HORSESHOE RIDGE SUBDIVISION 1ST AMENDMENT

SITE PLAN REVIEW

RETAIL

2ND SUBMITTAL 10/31/2019

COVER SHEET

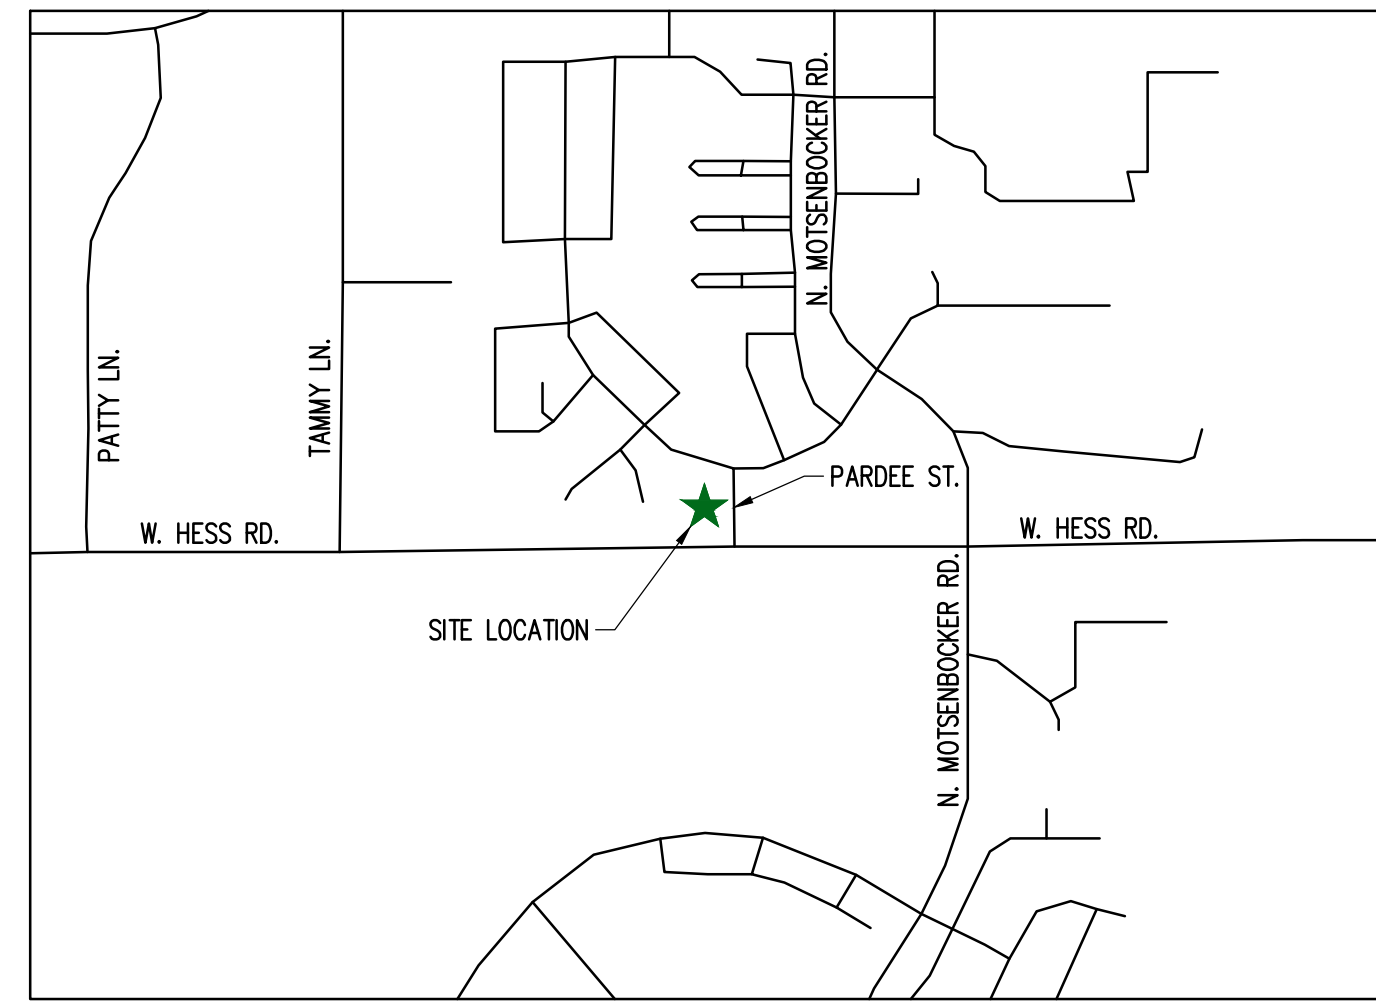
Remove all +/- and provide exact dimensions throughout the site plan including the cover page.

Please provide a bicycle parking detail in order to determine if the proposed structure meets the requirements outlined in Section 13.06.060.

Please update the Site Data Table to include required bicycle parking and provided.

Per page two of the proposed site plan, all stalls next to landscaping are 8' x 19' in size.

SHEET TITLE
SITE PLAN

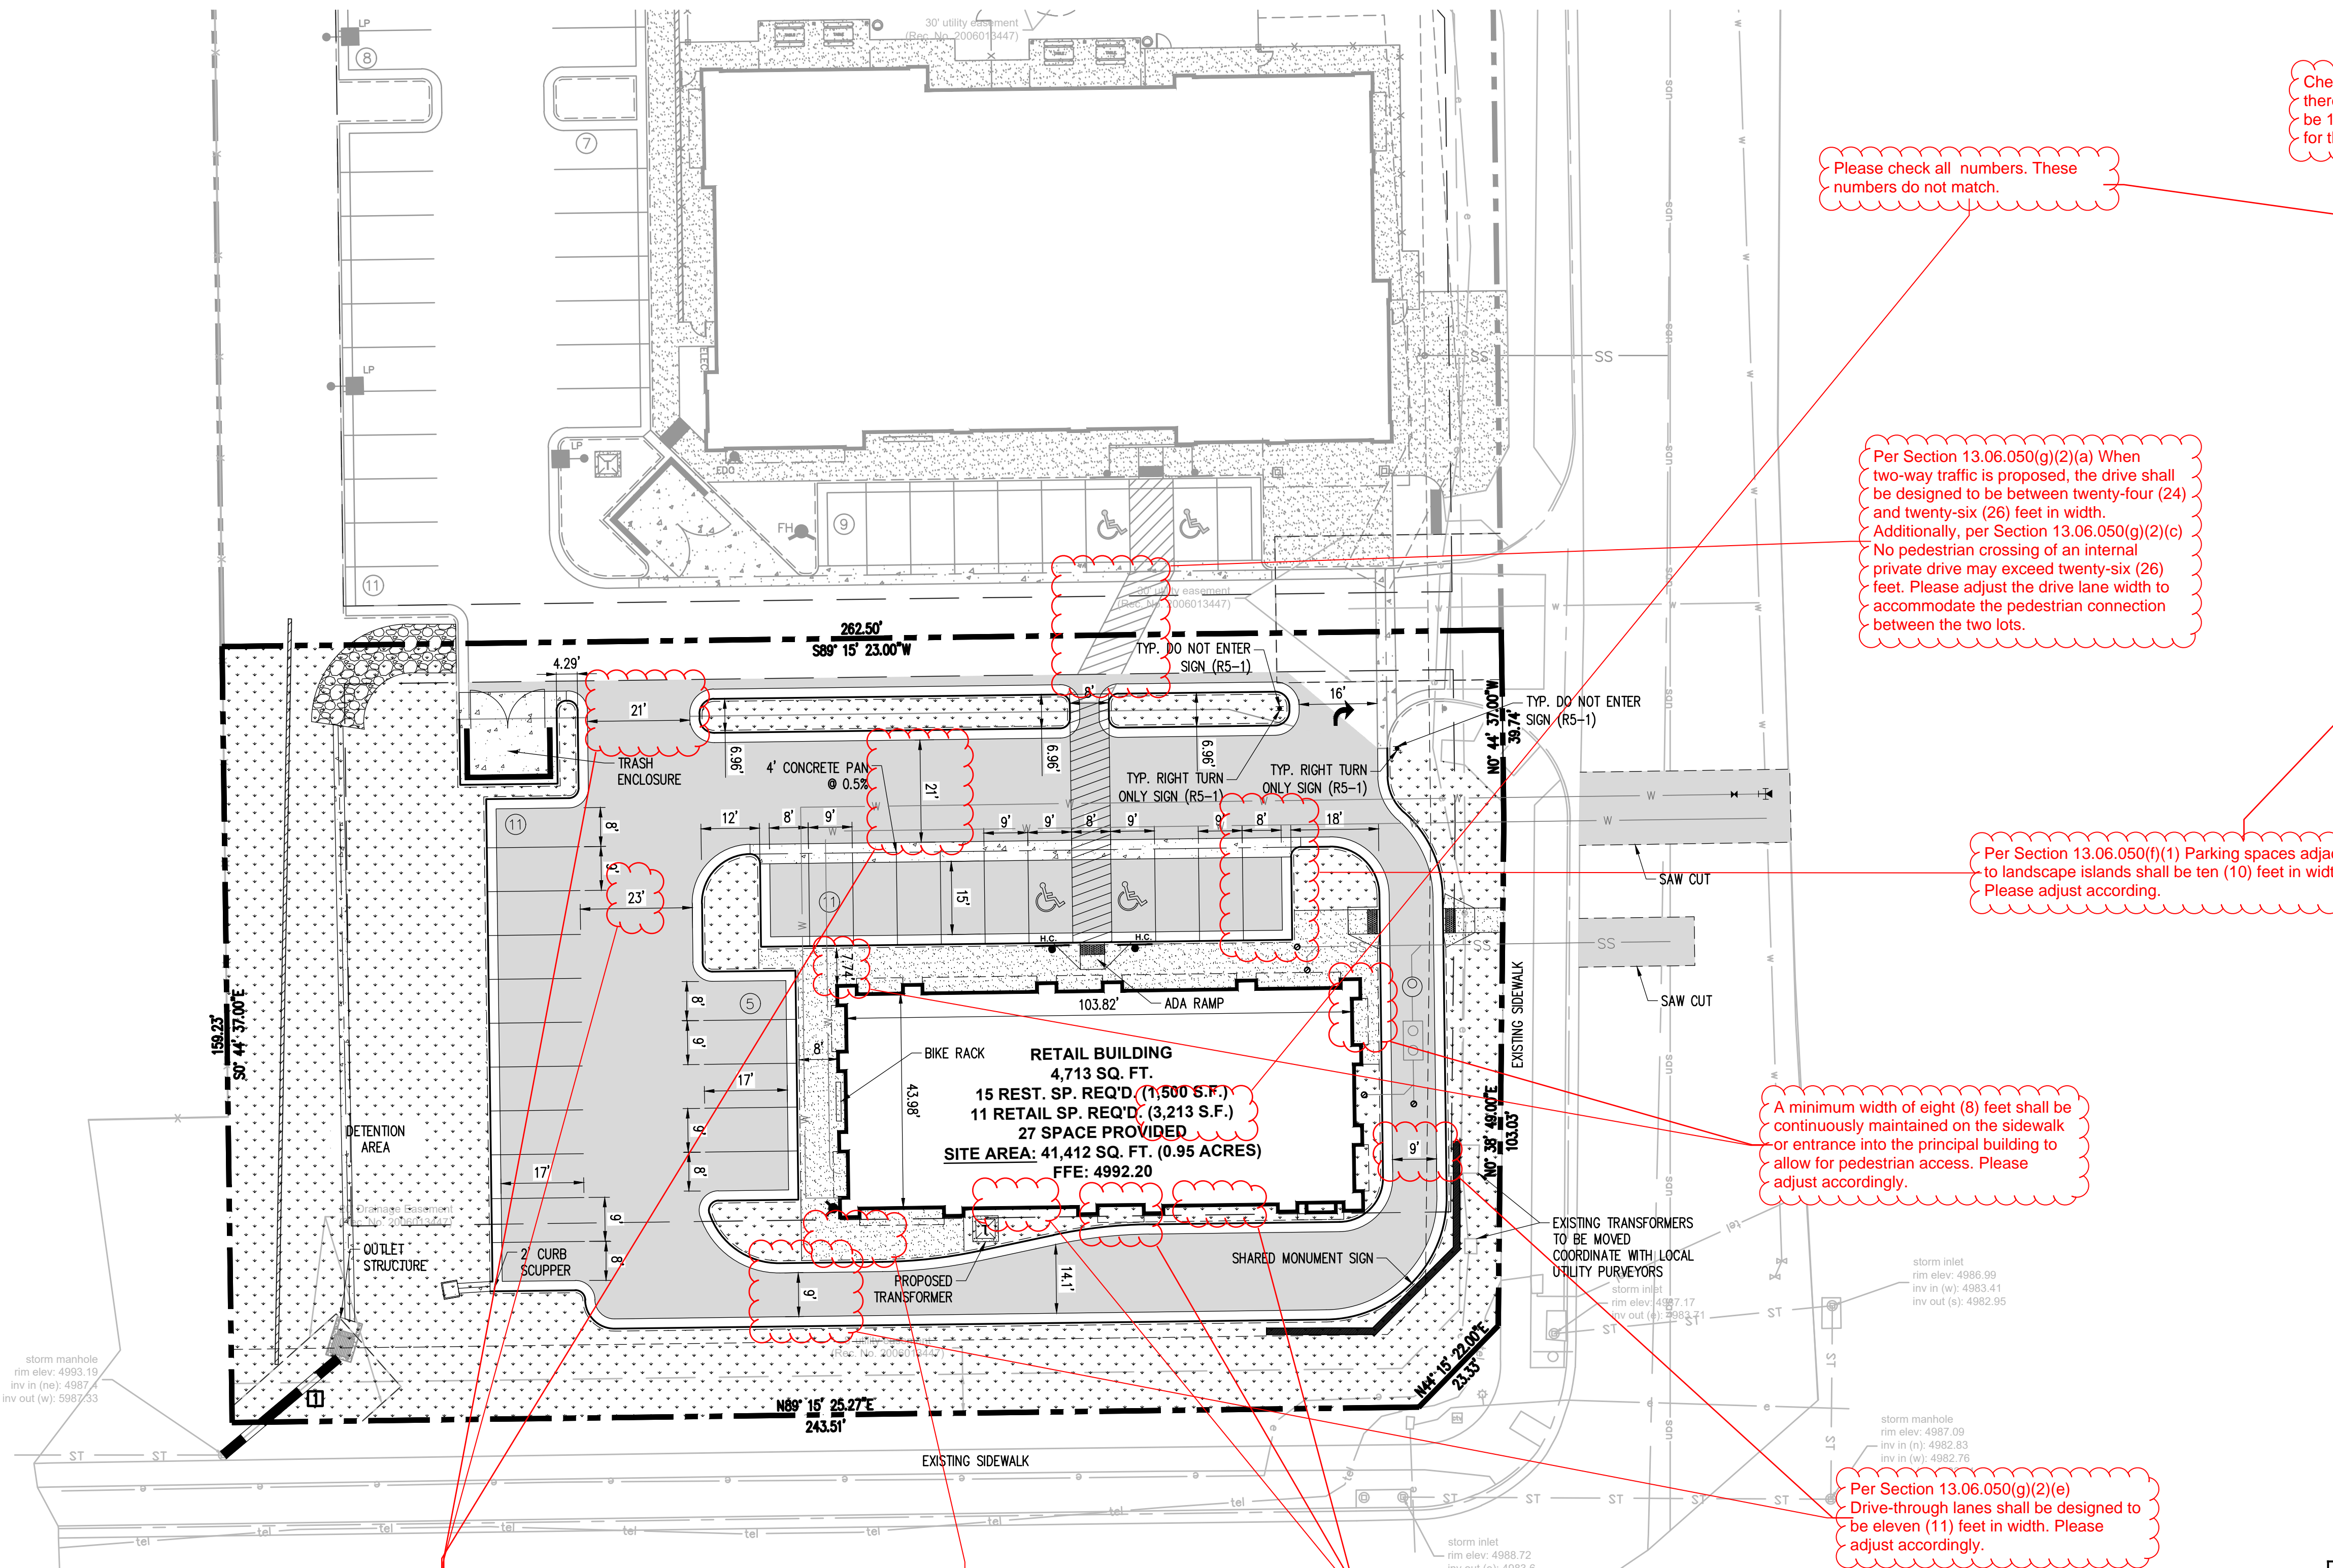
Check math...11.19 therefore there would be 11 spaces required for the retail.

Please check all numbers. These numbers do not match.

Per Section 13.06.050(g)(2)(a) When two-way traffic is proposed, the drive shall be designed to be between twenty-four (24) and twenty-six (26) feet in width. Additionally, per Section 13.06.050(g)(2)(c) No pedestrian crossing of an internal private drive may exceed twenty-six (26) feet. Please adjust the drive lane width to accommodate the pedestrian connection between the two lots.

Per Section 13.06.050(f)(1) Parking spaces adjacent to landscape islands shall be ten (10) feet in width. Please adjust according.

A minimum width of eight (8) feet shall be continuously maintained on the sidewalk or entrance into the principal building to allow for pedestrian access. Please adjust accordingly.

Per Section 13.06.050(g)(2)(e) Drive-through lanes shall be designed to be eleven (11) feet in width. Please adjust accordingly.

Per Section 13.06.050(g)(2)(a) When two-way traffic is proposed, the drive shall be designed to be between twenty-four (24) and twenty-six (26) feet in width. Please adjust accordingly.

Where is the drive through menu board going to be located? Will there be over head covering? Please provide a detail.

Egress doors for the public or employees cannot open to landscaping beds. This landscaping will not survive. There needs to be a sidewalk provided where employees or the public can exit the building.

4
A-2
PROPOSED SOUTH ELEVATION (REAR)
SCALE: 3/16" = 1'-0"

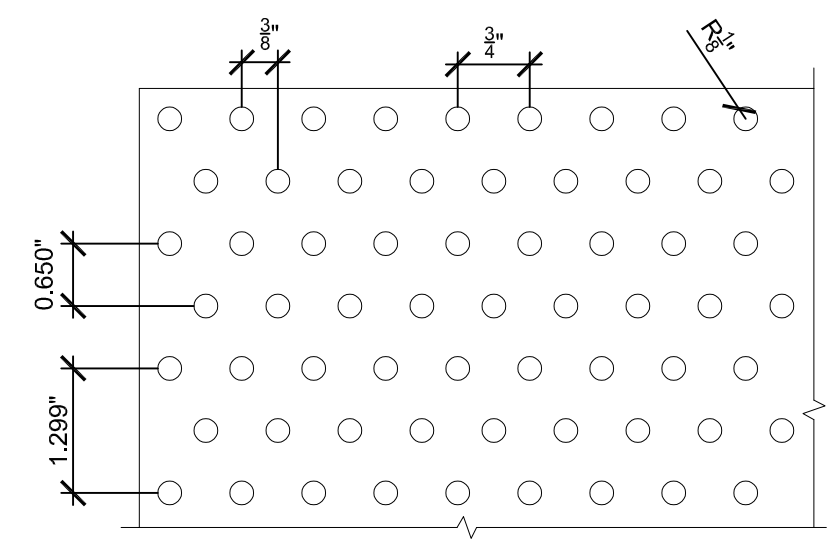
These two sections of the building should be enhanced in order to meet the 360 degree architecture requirement. Since the South elevation fronts Hess Road, this elevation should not have a "rear" appearance.

Extend the screen wall to screen the rear appearance along Hess Road.
